AGENDA

November 19, 2013

2. **Carlos Andrade dba Dunkin Donuts – 764 Elm St – Map 12, Lot 13;** Public Hearing for a major site plan for site improvements to include access reconfiguration, extension of the drive-thru lane and parking lot expansion. *New application – Meridian Land Services, Inc.*
3. **Carol Colburn – Osgood Rd & Woodhawk Dr – Map 51, Lot 1;** Public Hearing for a major open space subdivision creating twenty-seven (27) new residential lots. Original design review was held on 2/20/2007. *New application – Meridian Land Services, Inc*

Public Hearing for a major site plan for site improvements to include access reconfiguration, extension of the drive-thru lane and parking lot expansion

DUNKIN' DONUTS
PARKING LOT EXPANSION
LANDSCAPING PLAN
OCTOBER 6, 2013

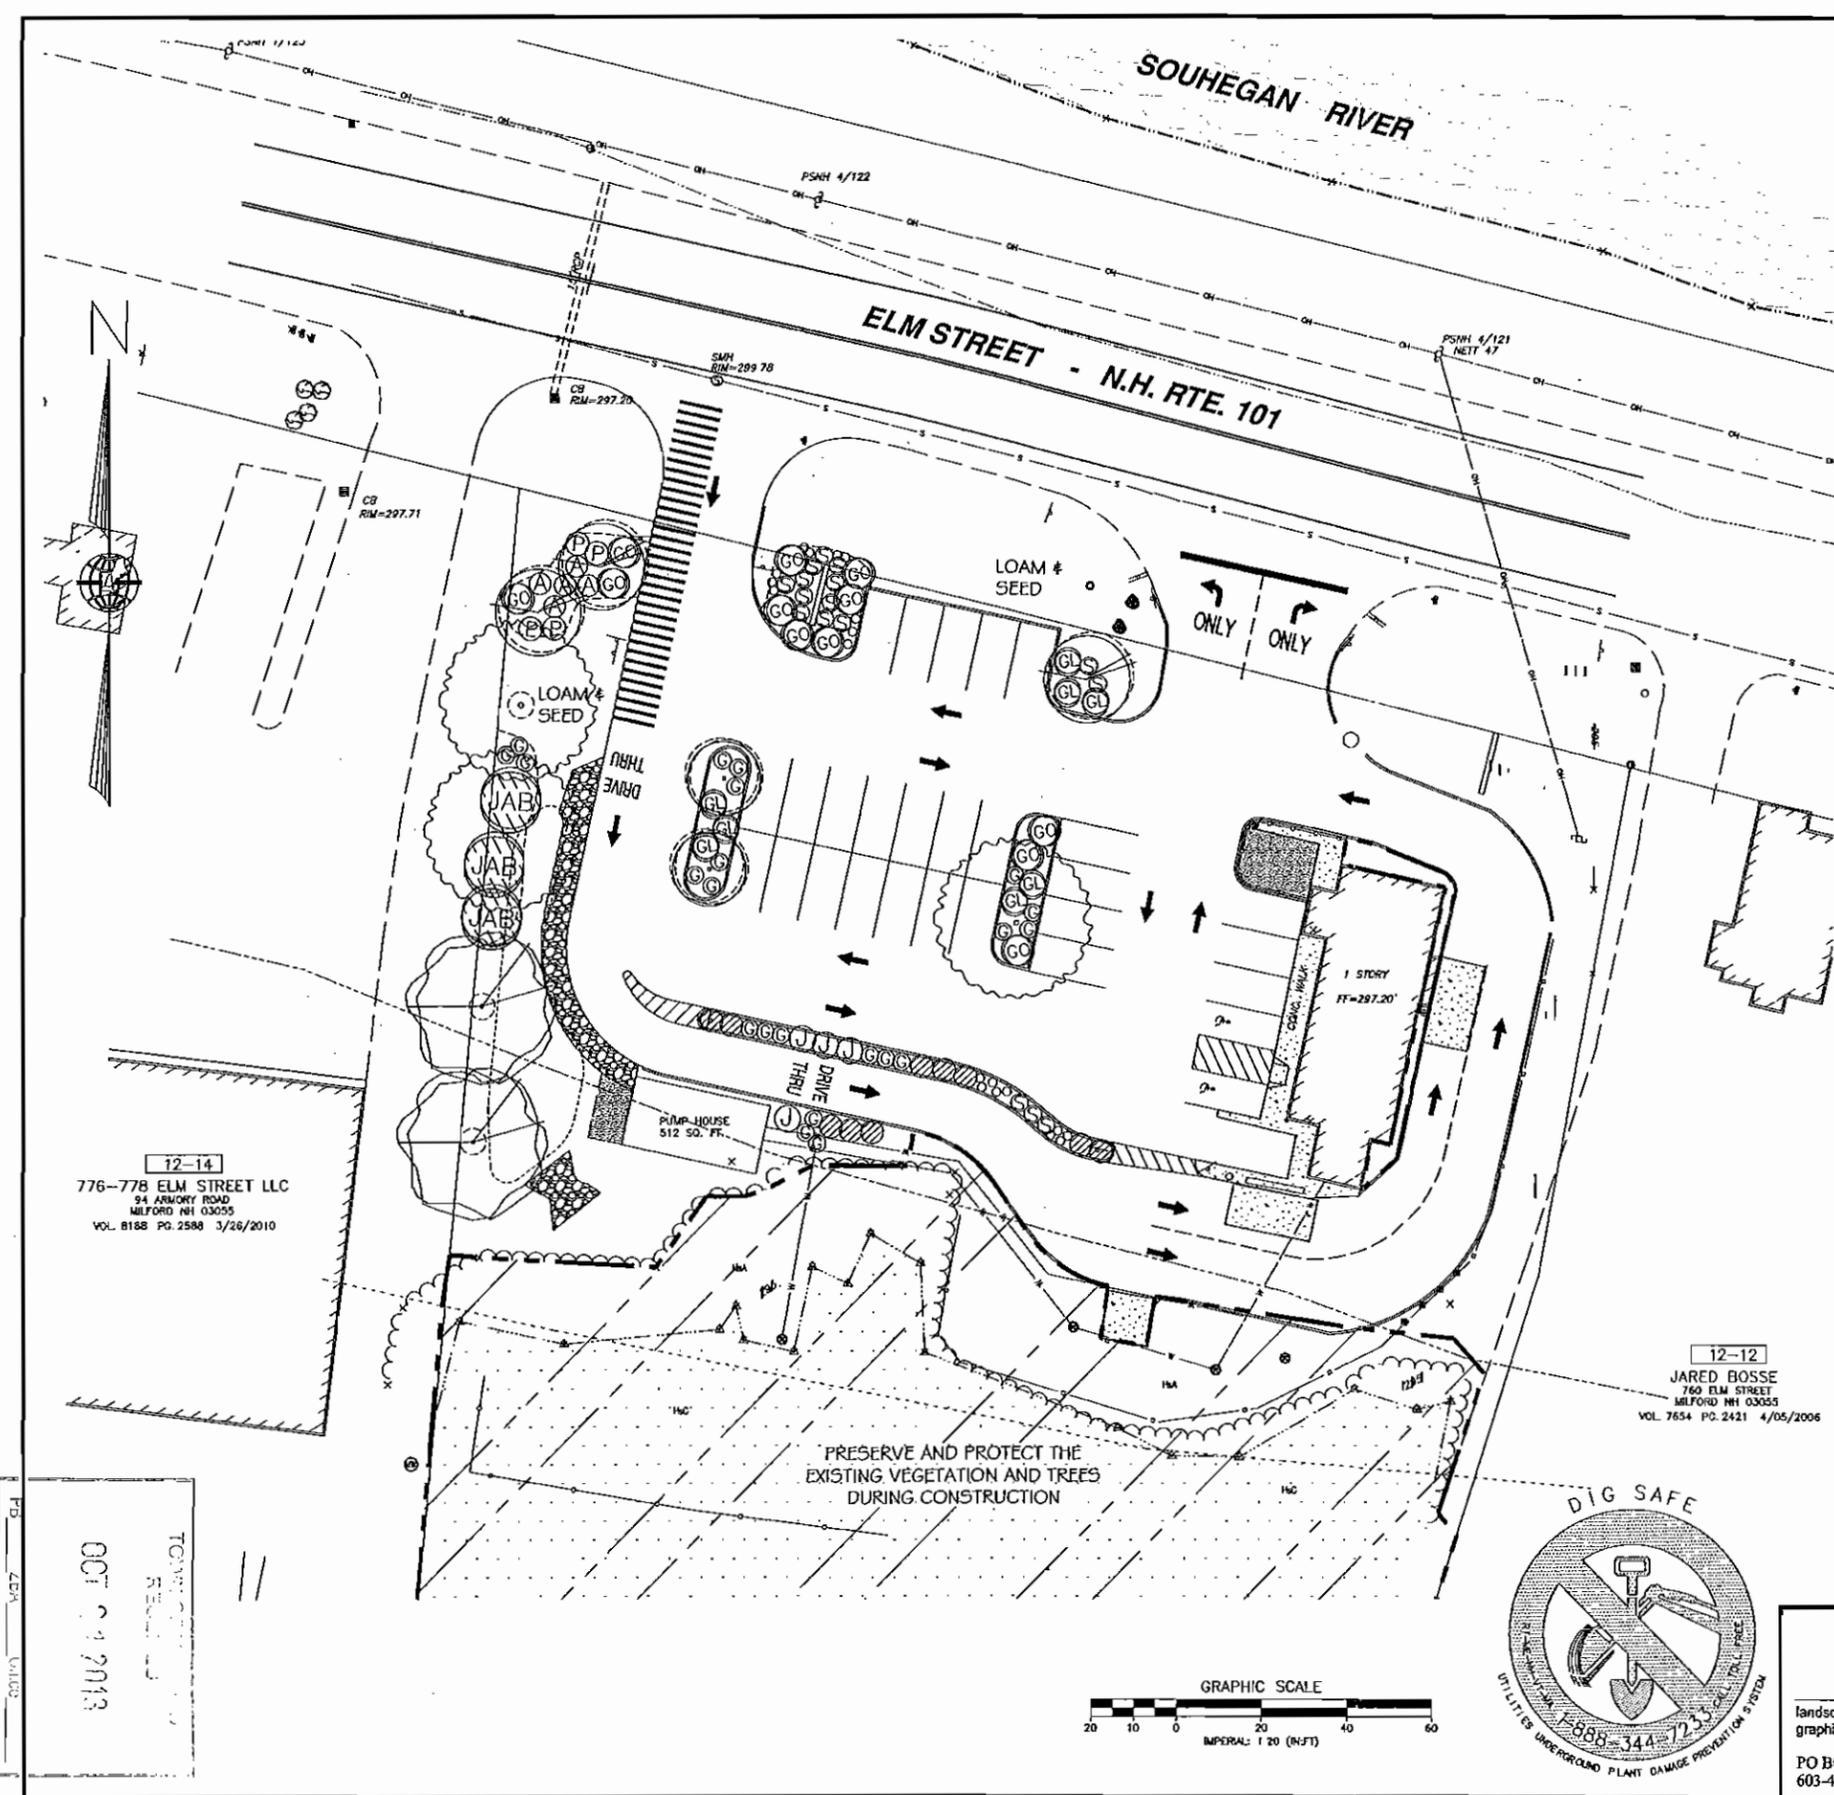
The Board should discuss landscaping of the building frontage. Currently, no plantings are set along the frontage of Dunkin Donuts as required by Milford Development Regulations 6.08.6 Landscaping Along Building Frontages. The Board should discuss with the applicant the possible inclusion of 3-5 small shrubs at this location.

1. Applicant discuss addition of landscaping along building frontage with Planning Board;
2. The owner’s signature shall be added to the final plan submitted for signature;
3. On sheet LS-1 (Landscaping Plan) the proposed relocation of the monument sign shall be displayed;
4. NHDES Permit number be added to the plan;
5. A note be added to the lighting plan stating “All outdoor lighting shall be downcast and so directed and shielded that no glare will spill out onto neighboring properties or roads.”;
6. A note be added to the plan stating: “Lot 12-13 lies within the Nashua and Elm Streets Corridor District.”
